**NOTICE TO TENDERERS NO: 12**

**TENDER NUMBER:** 277Q/2024/25

**DESCRIPTION:** Construction of a 300Mℓ Reservoir, Bulk Pipelines and Associated Infrastructure near Muldersvlei

**Query 2 a)**

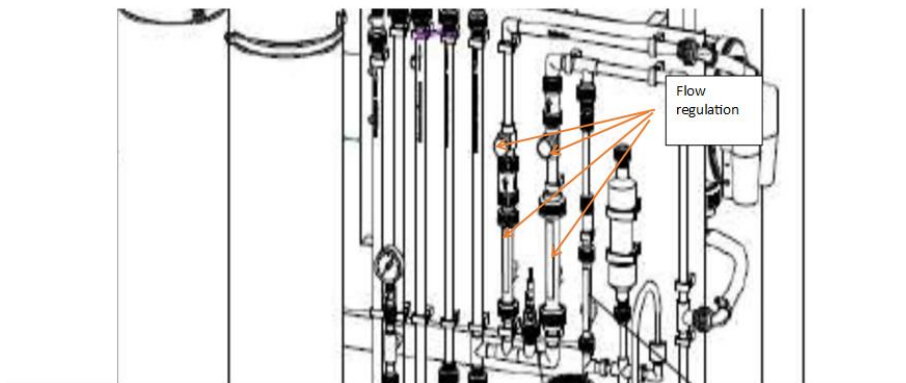
Q: *Total page number 1180 – Super Duplex Stainless steel volume flow regulator is not an option as a supply from the manufacturer, our units are PVC as shown below and we believe it is sufficient corrosion resistant; will this be acceptable?*

A: The volume flow regulator is part of the OEM package and the default material supplied is acceptable, whether PVC or a different material. Please refer to the amendment to the specification included in this notice.

- ATD2.1** On page number 1180, replace the 2<sup>nd</sup> sentence in the 4<sup>th</sup> paragraph of Section 2.12 of C3.7.7.1 *Detailed Mechanical Specification* that reads "A suitably sized flow regulator constructed of Super Duplex stainless steel (or better corrosion resistance) shall be used." with the following: "A suitably sized flow regulator shall be used. The volume flow regulator is part of the OEM package and the default material supplied is acceptable, whether PVC or a different material."
